### **Addendum Number Three**

Garden Plain High School  
Competition Gym  
Garden Plain, Kansas

Issued: May 8, 2009

### **HANNEY & ASSOCIATES ARCHITECTS**

E3.1-ELECTRICAL LIGHTING PLAN - BASE BID

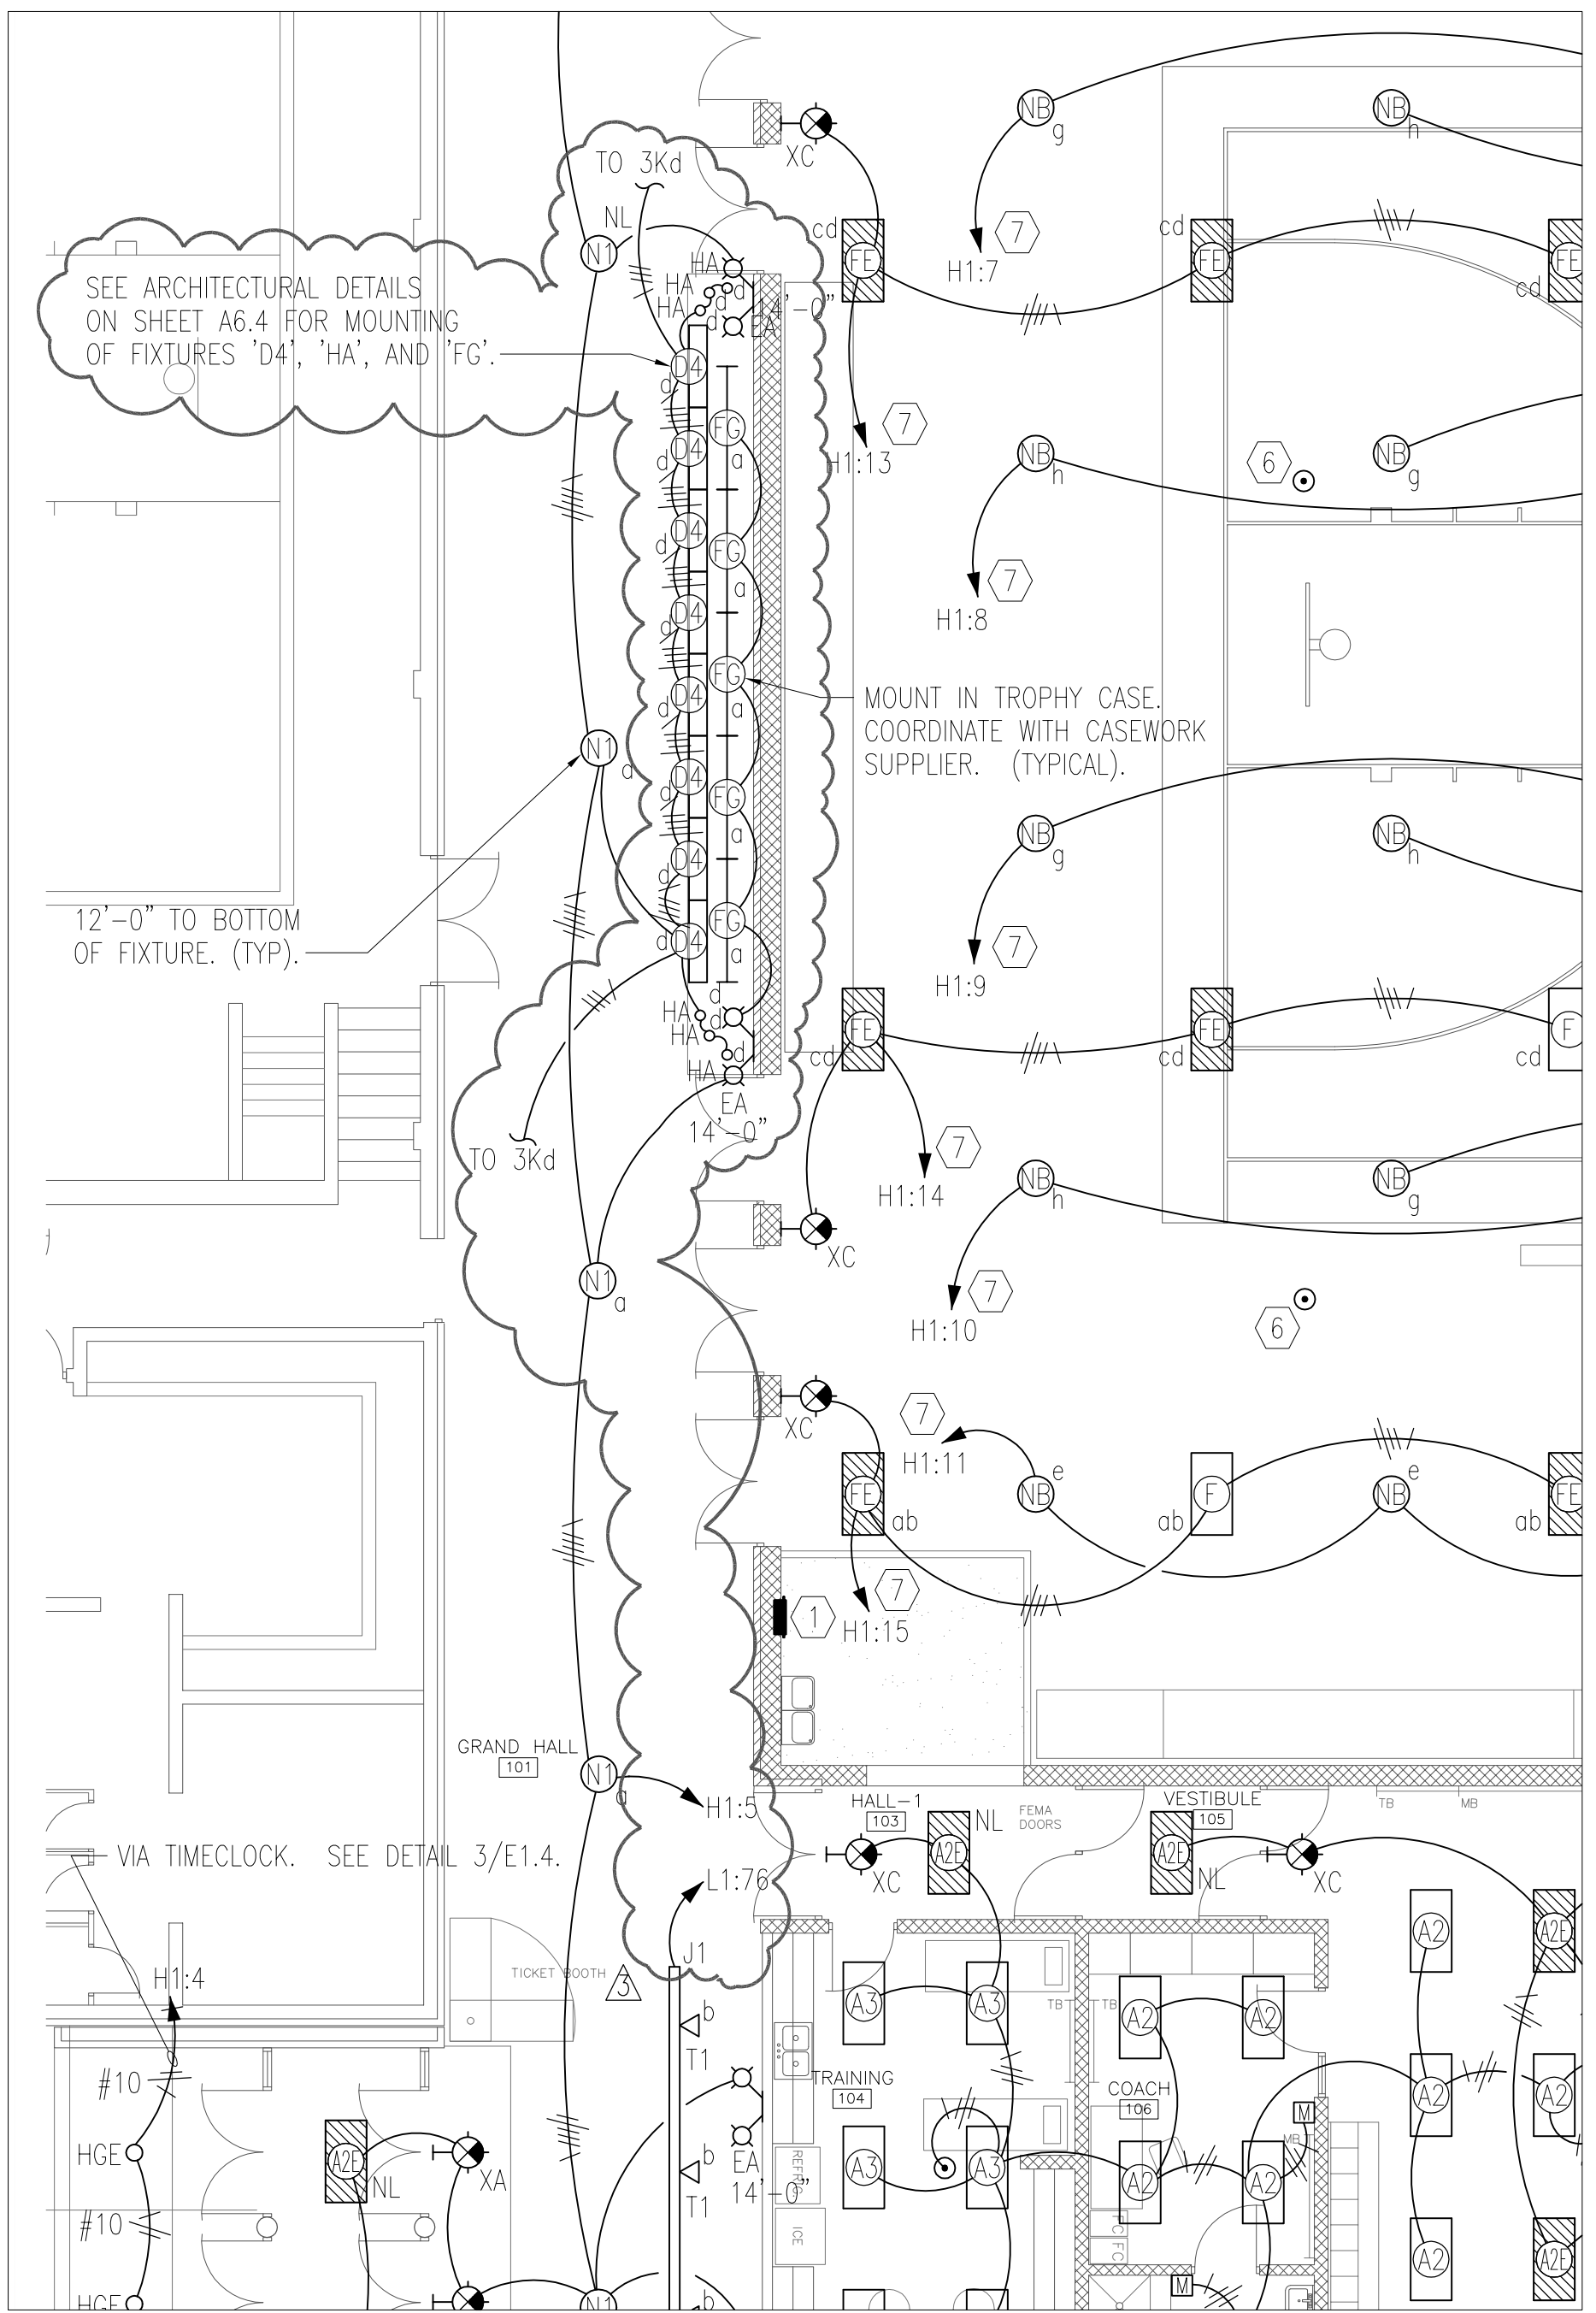
- 4.1 (4) Trophy Case lighting: One “FG” fixture was deleted and fixtures were shifted. “FG” fixture switching also changed. Compact fluorescent recessed downlight “HA” fixtures were added. “HA” shall be Williams PV45-126T-G24q-2-EB-UNV or approved equal. 1’x4’ low profile parabolic “D4” fixtures were added. “D4” shall be Williams LP5F-S44-114T5S-S-EB1-UNV or approved equal. Provide with Drywall Flange Kit. Reference Sheet E3.1 attached.

- 4.2 Add 3-way keyed switch to control trophy case accent lighting to each end of Grand Hall 101. Reference Sheet E3.1 attached.

E2.1 ELECTRICAL POWER/SYSTEMS PLAN - BASE BID

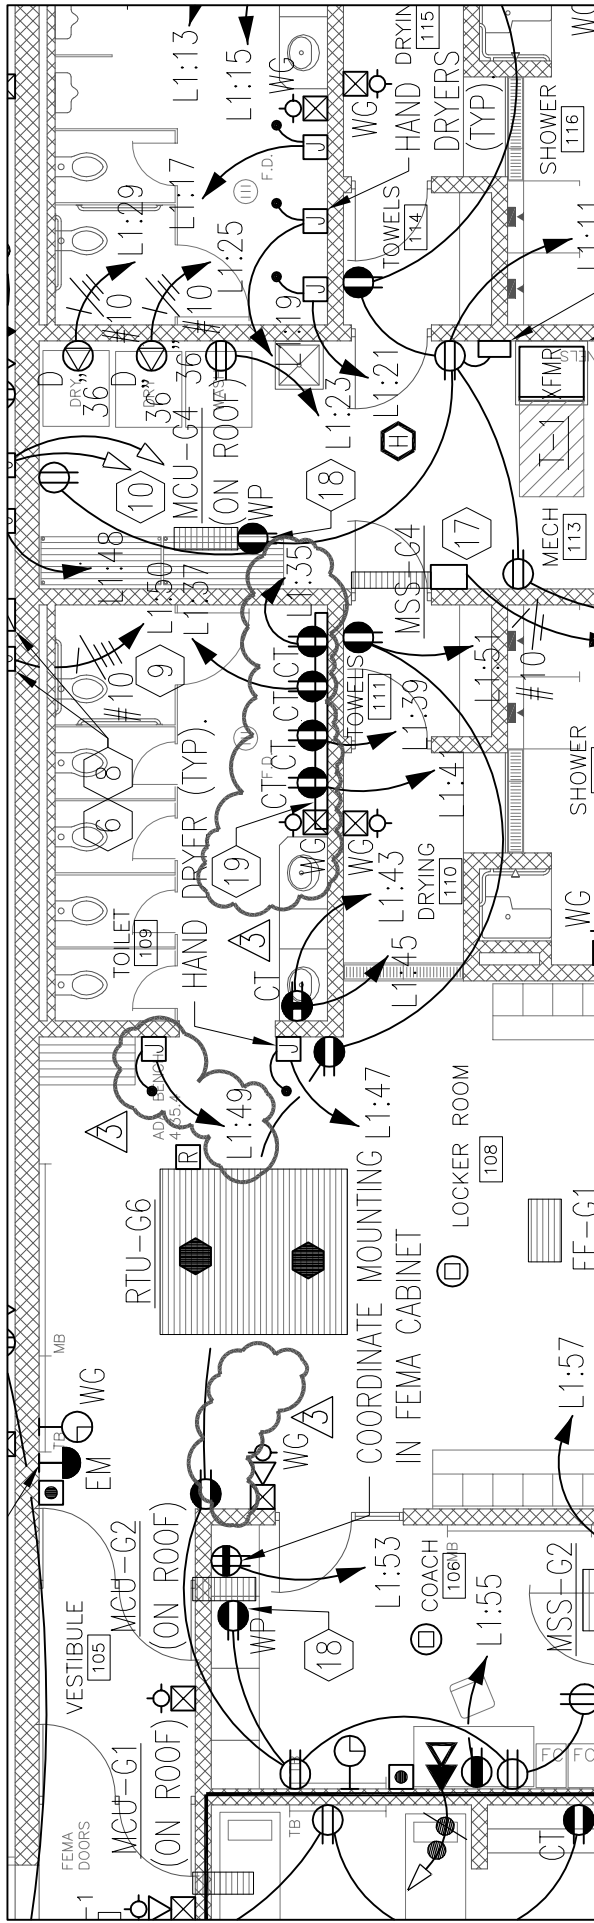
- 4.5 Add plugmold raceway in Toilet 109 above make-up counter. Reference Sheet E2.1 attached.
- 4.6 Relocate hand dryer in Locker Room 108. Reference Sheet E2.1 attached.

19 WIREMOLD 2000 SERIES SINGLE COMPARTMENT RACEWAY. PROVIDE DEVICES IN RACEWAY AS SHOWN. MOUNT RACEWAY BETWEEN TOP OF BACKSPLASH AND BOTTOM OF MIRROR. COLOR SHALL BE BY ARCHITECT.
